Access Compliance Report

Public Rights-of-Way

(Curb Ramps)

Intersection ID: 10319	Main Street: BACON_AV	Cross Street: ROZZELLES_FERRY_RD	Location: SE
ADA ID: DF9DEF7AAC9F	Ramp Type: PerpDiag	Initial Pass/Fail: Fail	Overall Compliance: No
		Severity Score: 35

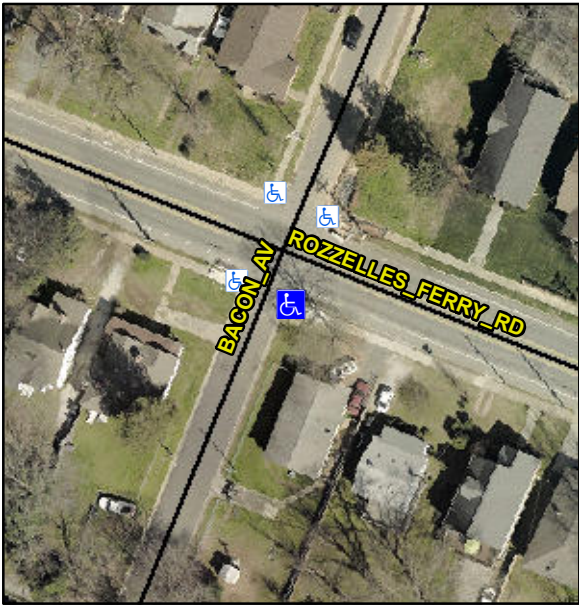
Codes/Mitigation Info/Possible Solution				Field Measurements/Component Compliance					
	Possible Solutions:			Compliance	Description	Data	Compliance	Description	Data
	Remove & Replace Curb Ramp With Two New Directional Ramps or Equivalent.			N/A	Ramp Length (in)	62.0	Yes	Ramp Slope (%)	6.6
				No	Ramp Width (in)	24.0	Yes	Ramp XSlope (%)	0.1
				N/A	Flare Type LT	N/A	N/A	Flare Type RT	N/A
				N/A	Flare Slope LT (%)	N/A	N/A	Flare Slope RT (%)	N/A
				N/A	Flare Traversable LT?	N/A	N/A	Flare Traversable RT?	N/A
				N/A	Landing Length (in)	N/A	N/A	DWS Provided?	N/A
				N/A	Landing Width (in)	N/A	N/A	DWS Contrast?	N/A
				N/A	Landing Slope (%)	N/A	N/A	DWS Length (in)	N/A
				N/A	Landing X Slope (%)	N/A	N/A	DWS Full Width?	N/A
Surveyor Notes:			N/A	Landing Curb? (Y/N)	N/A	N/A	DWS Offset (in)	N/A	N/A
			N/A	Shared Landing?	N/A				
PROW/ADA:			N/A	Gutter Ponding?	N/A	N/A	N/A	Gutter Slope (%)	N/A
Not Found, R304.5.1			N/A	Gutter Lip Ht (in)	N/A	N/A	N/A	Gutter X Slope (%)	N/A

N/A	Painted X Walk1?	No	N/A	N/A	Painted X Walk2?	No
				X Walk 1 Direction	To NE			X Walk 2 Direction	To NW
			N/A	X Walk 1 Width (in)	N/A	N/A	N/A	X Walk 2 Width (in)	N/A
				X Walk 1 Slope (%)	9.2			X Walk 2 Slope (%)	0.2
				X Walk 1 X Slope (%)	1.6			X Walk 2 X Slope (%)	0.5
Street 1 Name			ROZZELLES FERRY RD	N/A	Ramp inside XWalk1?	N/A	N/A	Ramp inside XWalk2?	N/A
Stop Condition-Street 2			None		Road Slope (%)	0.5	N/A	Clear Space?	N/A
Street 2 Name			BACON AV		Road X Slope (%)	1.4	N/A	Clear Space to XWalk (in)	N/A
Stop Condition-Street 1			StopSign	N/A	Any Obstructions?	N/A	N/A	Storm Grate/Utility Hazard?	N/A
				Obstruction Type				Storm Grate/Utility Type	
						N/A			N/A
						Yes		Surface Condition? (G/P)	Good
Total Cost:			\$ 3200.00
